**PLANNING COMMISSION
CITY OF FREDERICKSBURG, VIRGINIA AGENDA
June 8, 2016
AGENDA
7:30 P.M.
COUNCIL CHAMBERS, CITY HALL**

4. Unfinished Business/Action Item
 - 4.I. SE2016-01 - Timbernest, LTD Special Exception Requests

TO: Chairman McAfee and Planning Commission Members
FROM: Mike Craig, Zoning Administrator
DATE: June 1, 2016 for the June 8 meeting
SUBJECT: SE2016-01 Timbernest, LTD requests Special Exceptions from general density and floodplain density to redevelop 506 – 512 Sophia Street (GPIN 7789-23-5802) and a portion of 525 Caroline Street (GPIN 7789-23-3825) in the Commercial-Downtown (CD) Zoning District.

EXISTING SITE PLAN TOWNHOMES AT RIVERWALK SQUARE

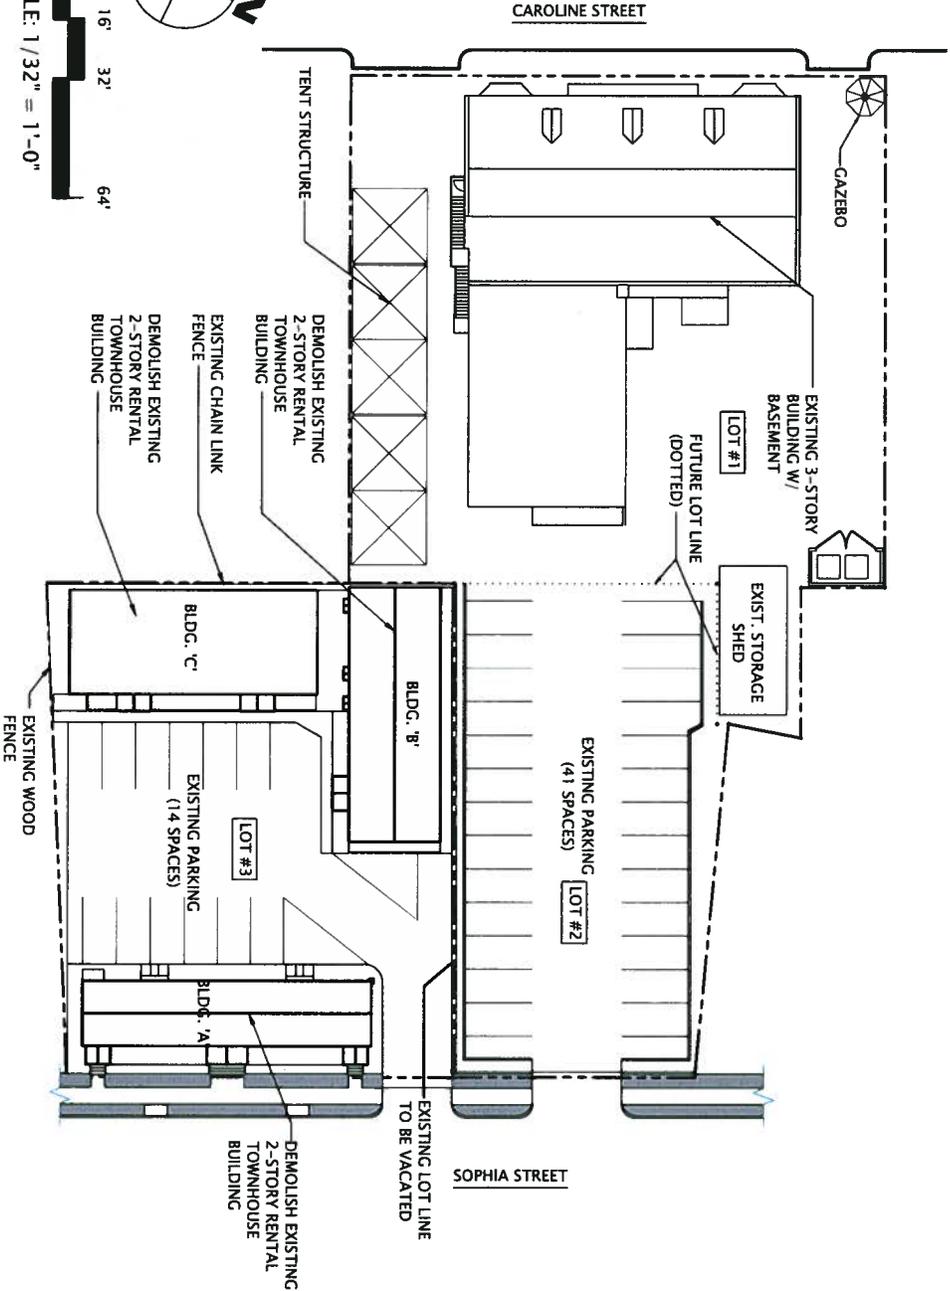
Mr. Pates referenced the existing site plan sheet. He confirmed that the Fredericksburg Square Property and the parking lot behind it are one property, consisting of about a half-acre, and then where the apartment buildings are is another parcel.

A2

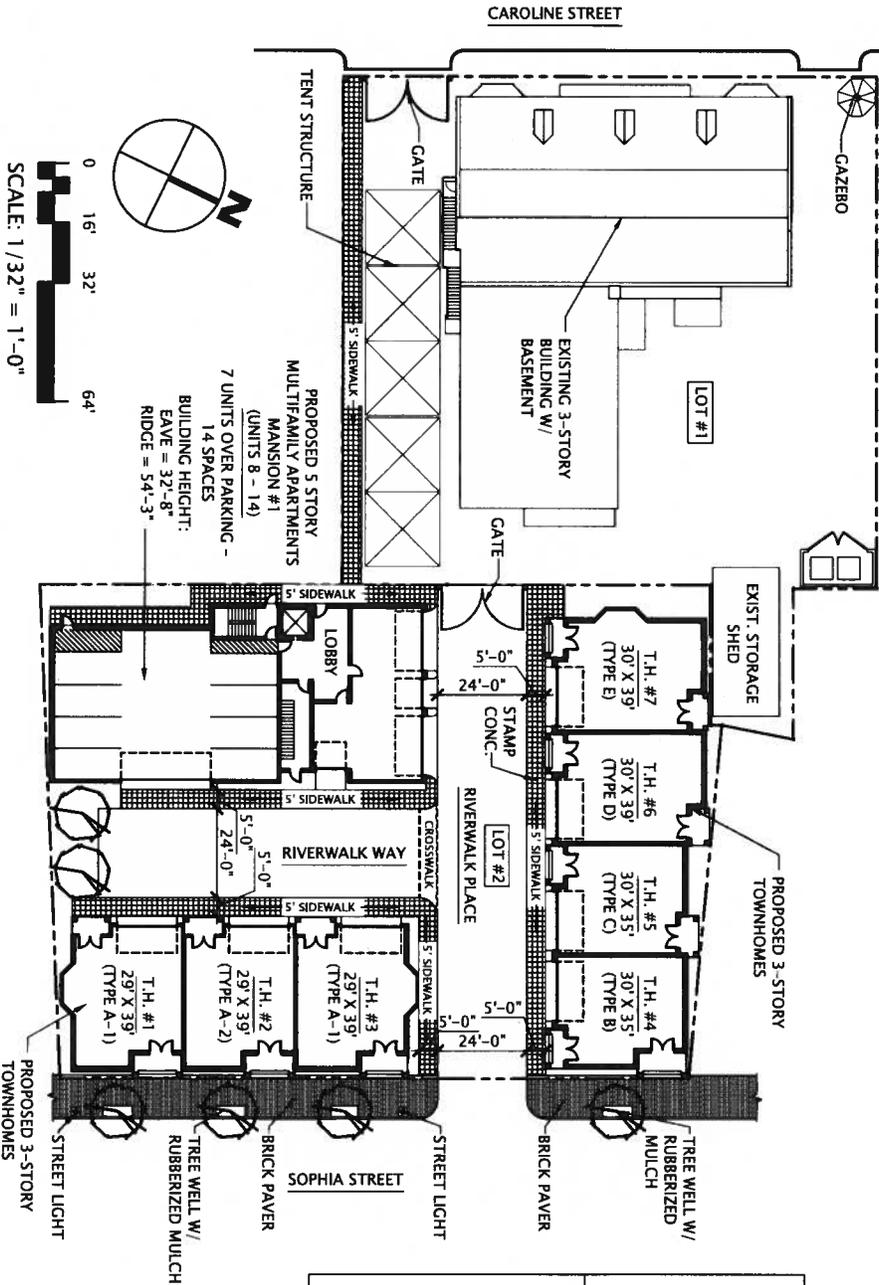
Timbernest LTD proposes to reconfigure their two properties as shown on their "Proposed Site Plan sheet A2" to create a 0.52 acre parcel on which seven townhomes and seven multi-family dwelling units would be built. The density for the parcel would be 29 units per acre. The CD zoning district generally permits multi-family units at 18 units per acre and townhomes at 12 units per acre. § 72-51.1 requires that the generally permitted density be cut in half for properties where more than 25% of the land is in one hundred-year frequency floodplains, which would limit density on the property to 9 and 6 units per acre respectively.

- §72-51.3 Lots. This section requires that lots in the CD Zoning District either front on public streets, private streets, or a driveway meeting the standards in § 72-52.4. The seven multi-family building and Townhomes 5-7 (potentially equating to a total of four lots housing a total of 10 units) will be located mid-block and will be primarily accessed by an alley. Alleys are meant to provide vehicular access behind buildings in tandem with a complete street with unbroken pedestrian access. The Applicant has added a pedestrian connection to Caroline Street in order to provide for a better, more diverse access plan than previously submitted.

- § 72-53.1.D(1)(d)[1][a] Off-street parking; configuration; arrangement. This section requires that all off-street parking and circulation areas be arranged to facilitate access by and safety of both pedestrians and vehicles. Pedestrian access to Townhome 5-7 is deficient. The majority of the “sidewalk” will be comprised of driveway entrances and will put pedestrians and vehicles in conflict with one another. To address this deficiency, the Applicant added stamped concrete sidewalks to the Riverwalk Square plan. While this change of materials does make the pedestrian area more visible, the conflict between the pedestrian and vehicles using Townhome 5-7 remains.

The proposal will eliminate 26 off-street spaces. Redeveloping this essential service area for a different use would shift parking off-site into the City's public parking network. The Applicant has not provided a sufficient plan to replace the parking.

The Applicant has not fully explored offset this impact as much as possible. The Applicant should revise his plan to move the proposed density to the portion of the lot fronting Caroline Street thus preserving the service area interior to the block. Without doing so, at a minimum the applicant should eliminate the defunct curb cuts along Caroline Street and restripe the parking lane the public parking supply would gain four additional on-street spaces. The Applicant could also offset the loss of usable spaces by paying into the Downtown Parking Fund or creating an off-site shared parking agreement.

SOPHIA STREET ELEVATION

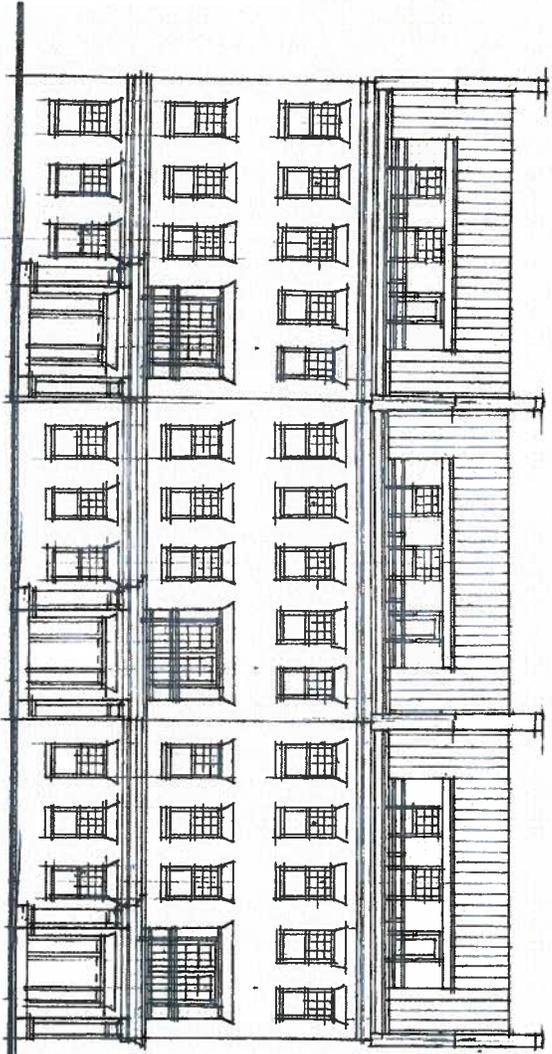
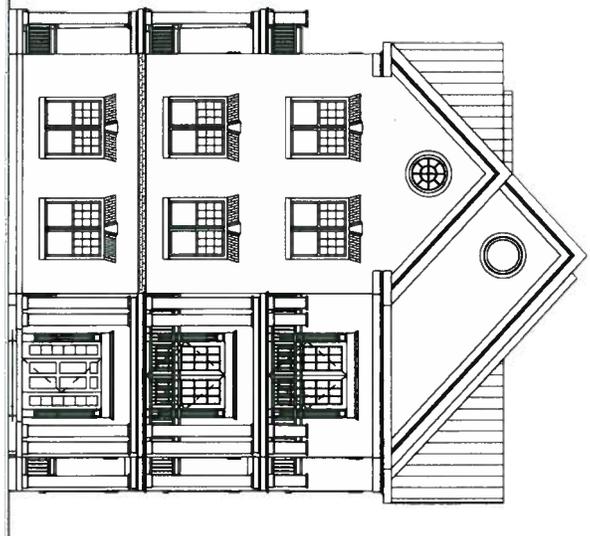
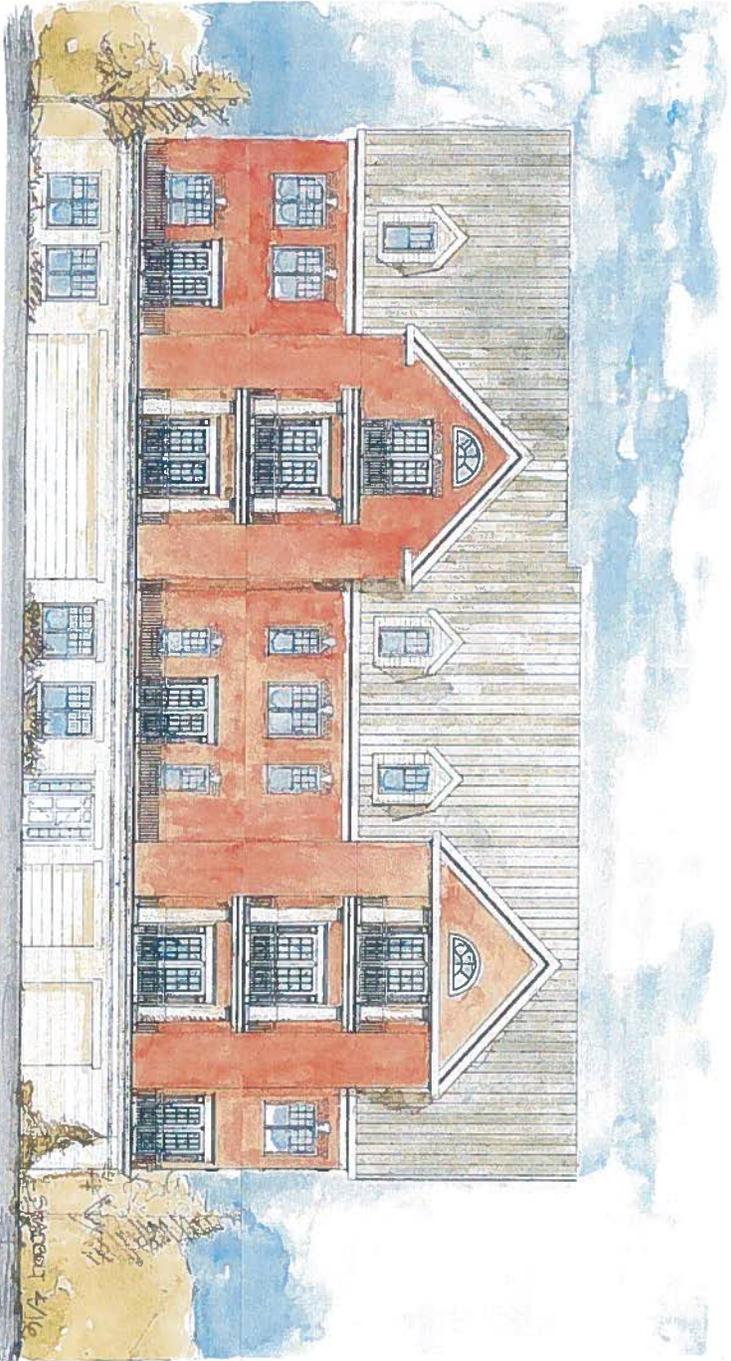
- The membership was generally in favor of the density special exception as long as the architecture could be made to fit into the surrounding context.
- The main architectural concern was about the mass and scale of the townhomes along Sophia. The Applicant has changed his architectural design in response, but the ARB has not evaluated the new proposal.
- The site layout is generally acceptable. Adding units mid-block is an accepted way to add density in the downtown.
- Two members were not in favor of with permitting the demolition of the existing apartment buildings. However, it was noted that the ARB previously approved demolition of the buildings in 2009.

Since the Public Hearing on May 11, the Applicant has added both automobile and pedestrian connectivity into their plan, has provided a full public streetscape along Sophia Street and he has revised his architectural elevations in order to address the ARB's concerns. The density request meets a significant portion of the goals and policies in the Comprehensive Plan.
